DESCRIPTIVE REPORT

Registry No. F00464

Locality DETROIT AND ST. MARY'S RIVERS

ATLANTIC HYDROGRAPHIC BRANCH
EVALUATION REPORT FOR F00464 (2000)

FE00464
OPR-W408-NRT1
St. Mary's River - Michigan
Section from Chart 14882
NOAA Launch 517
45
27
Bow Island
37
30
40
Submerge
Net Stake
72
84
46
P9
Surv

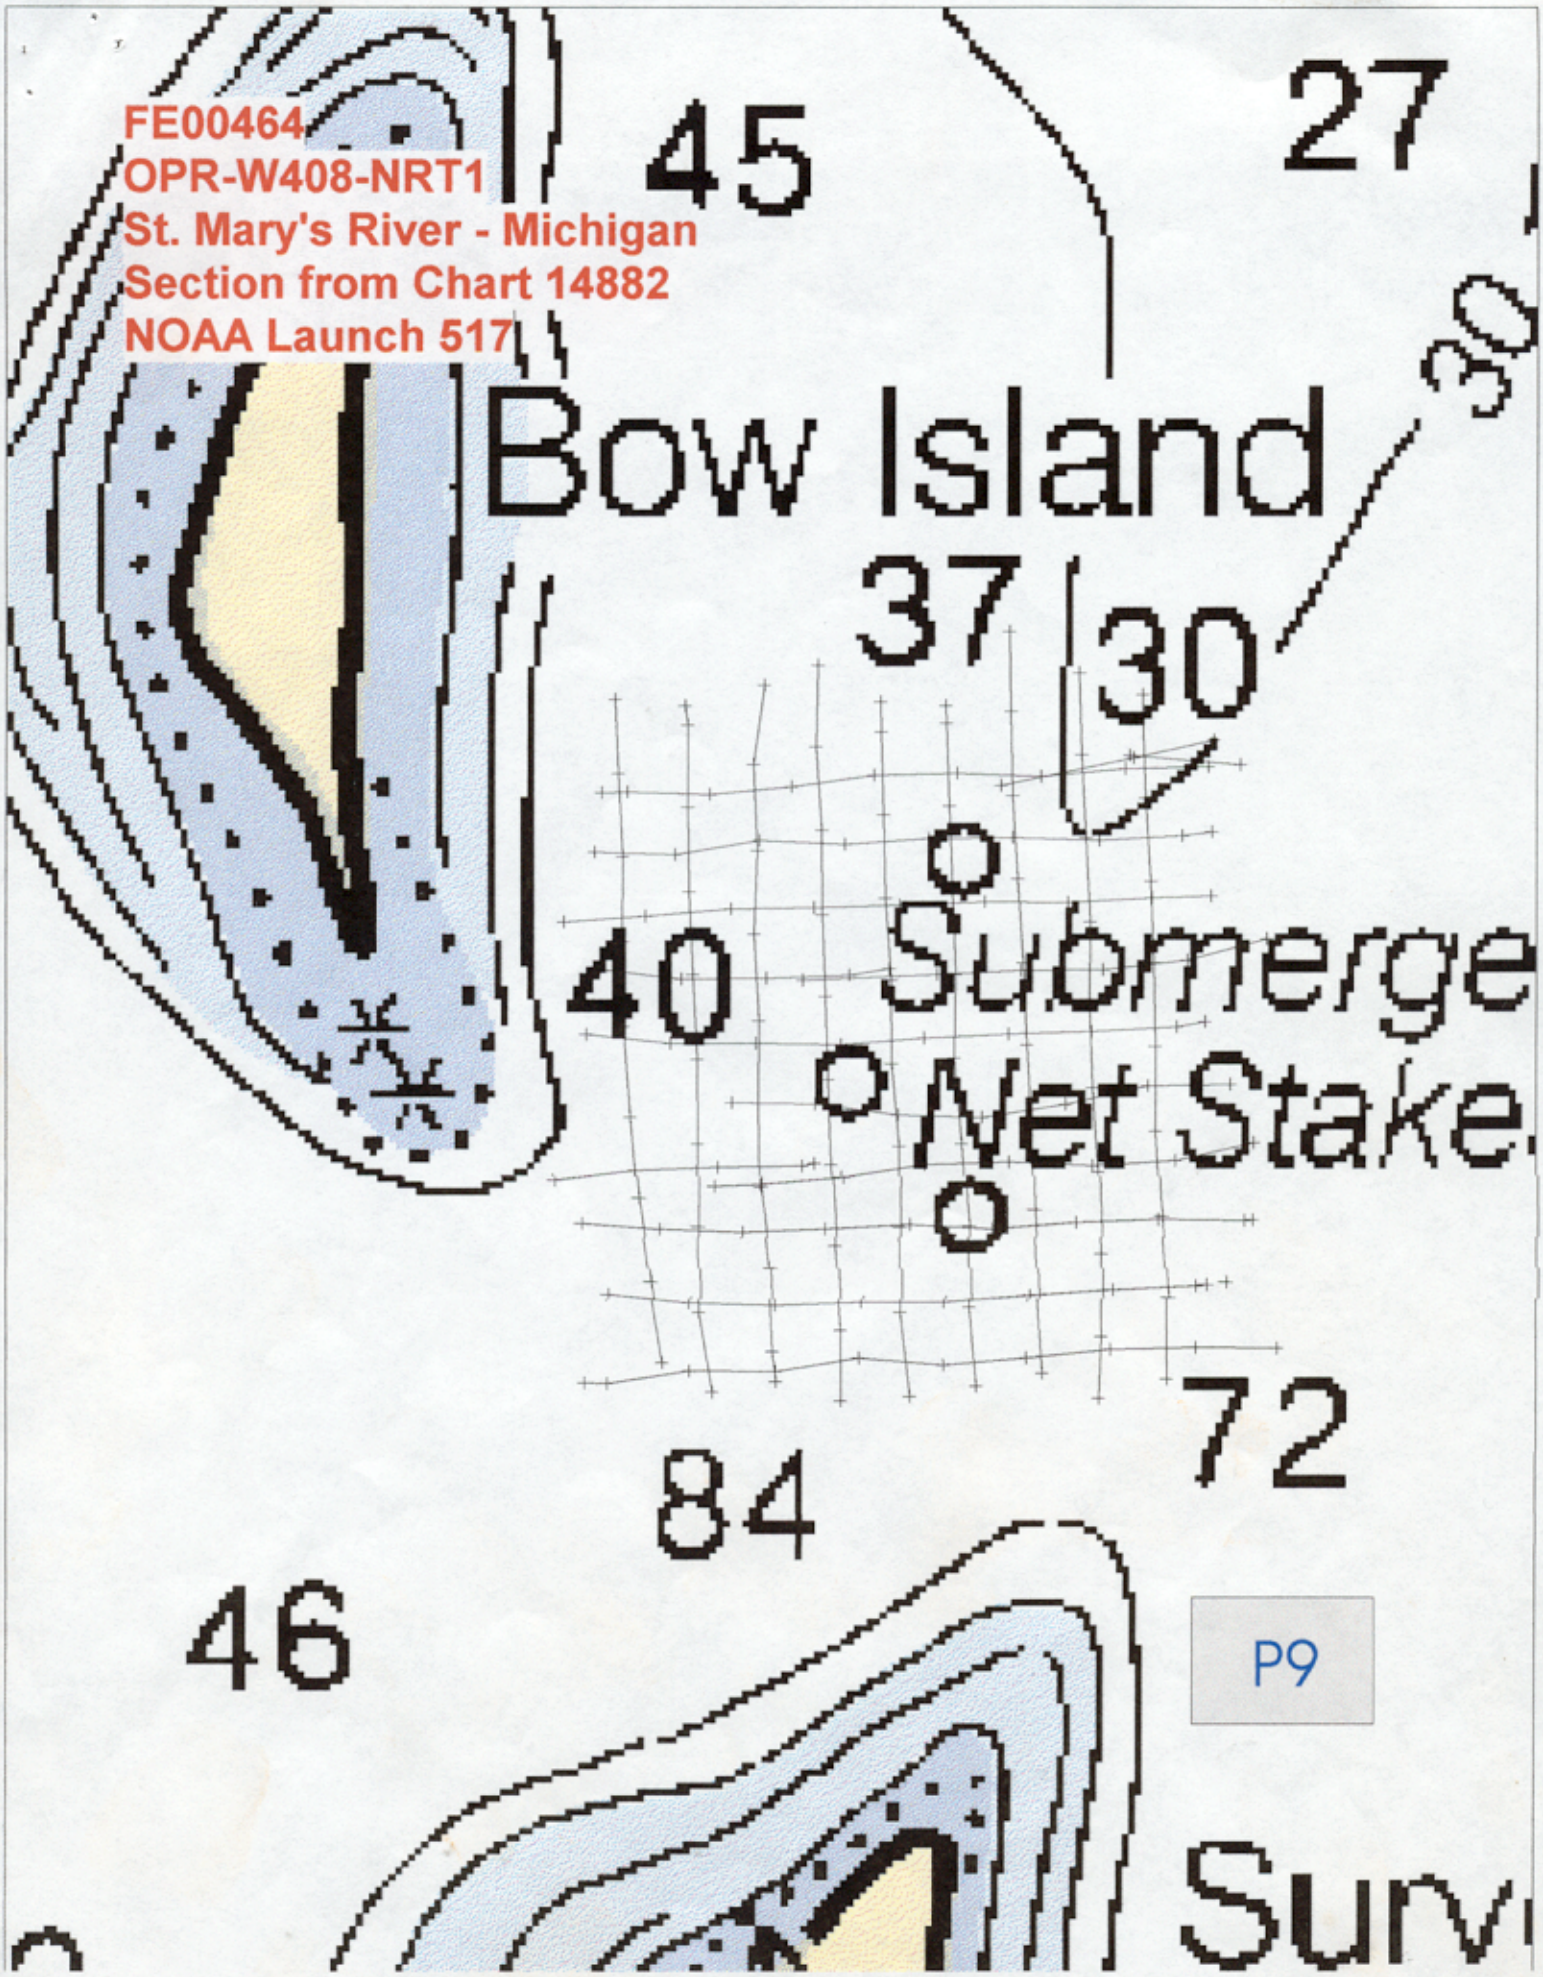
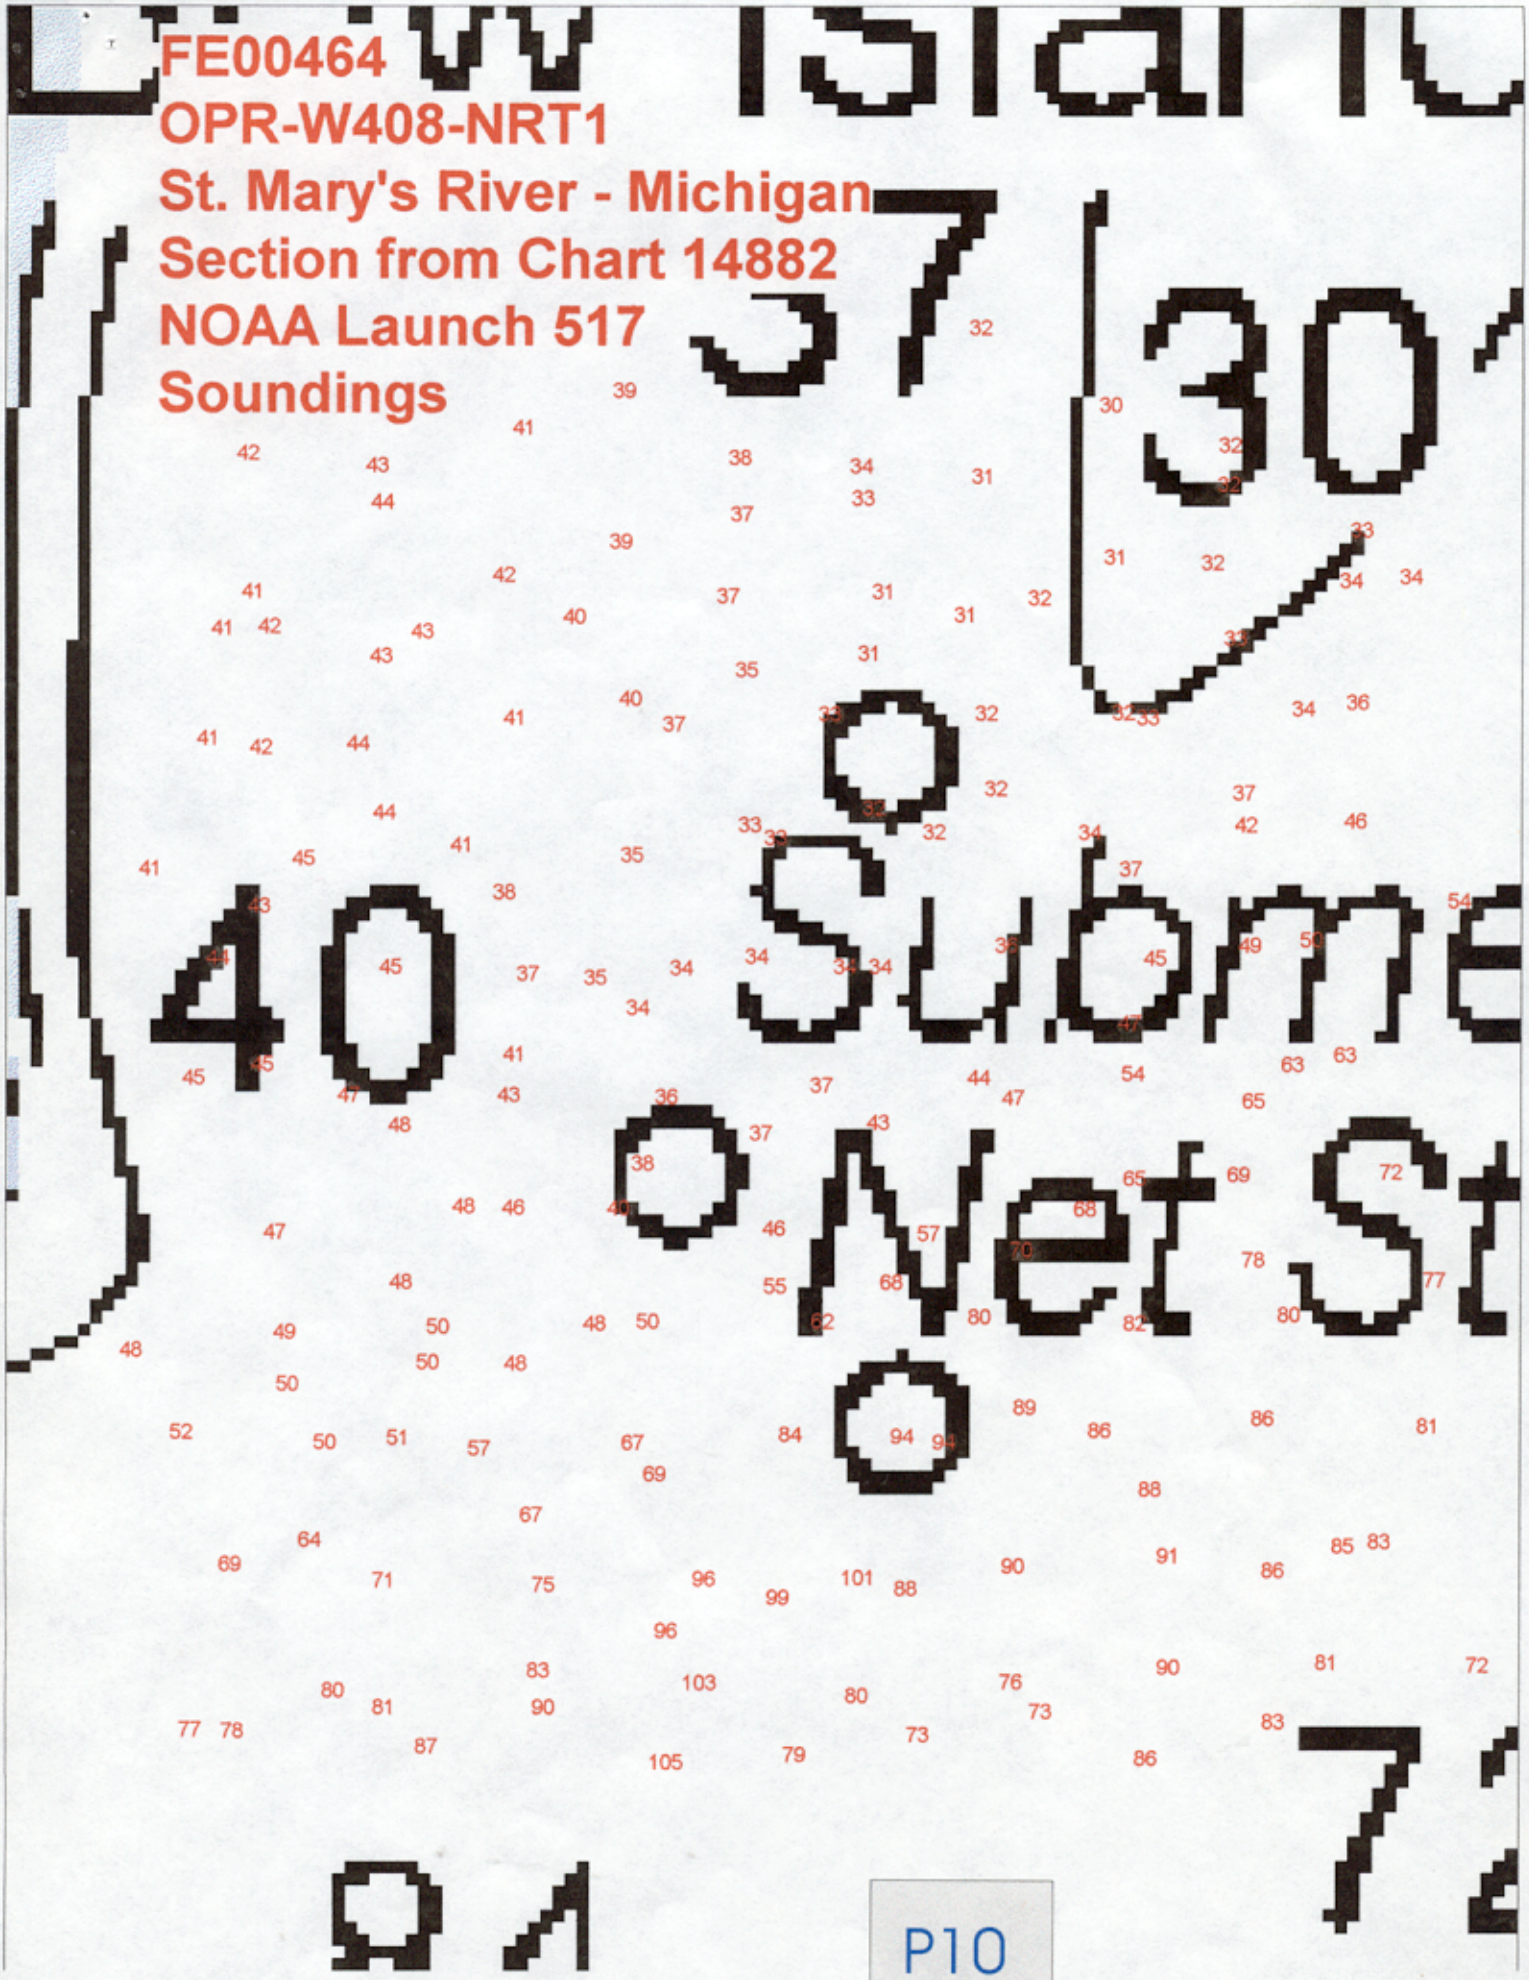
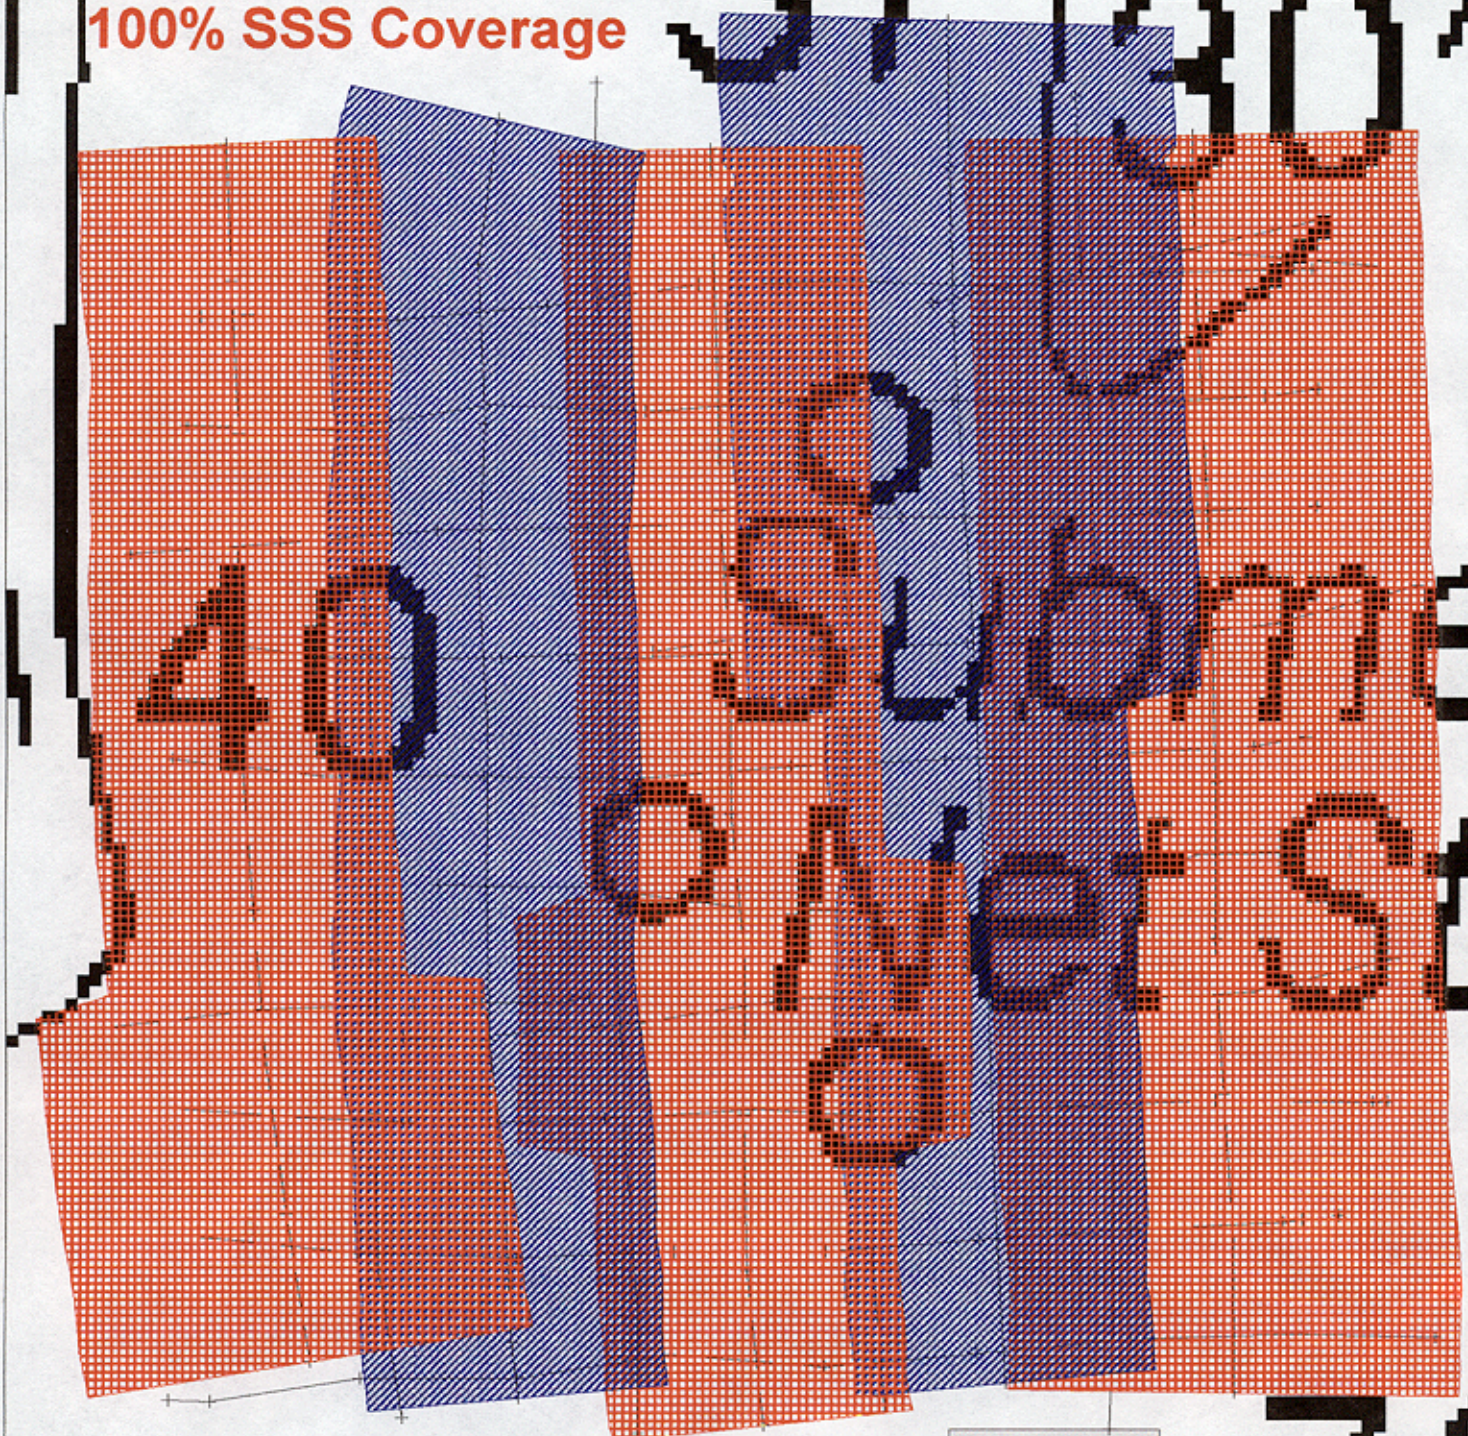
Feature 10 was investigated with 400% coverage side scan sonar. Nothing was found. Sounding, trackline, and swath plots are included with this survey. Concur (1) Plots associated with this item are appended to This Report. See E+A Report Sect D1.H.1. page 4.

1) ENC FEATURE #10 was assigned to verify the

existence of the "submerged net stakes" charted in the vicinity of Latitude 46°02'05.32"N, Longitude 83°49'23.05"W. The field acquired 400% side scan sonar coverage over the charted stakes with negative results. No indication of the submerged net stakes was found by the present survey. It is recommended that the symbols and labels for the "submerged net stakes" be removed from the chart. Also, reposition the (see note D)note in the vicinity of this item. Field plots P9 - P15, appended to the end of this report, show the field work done on this item.
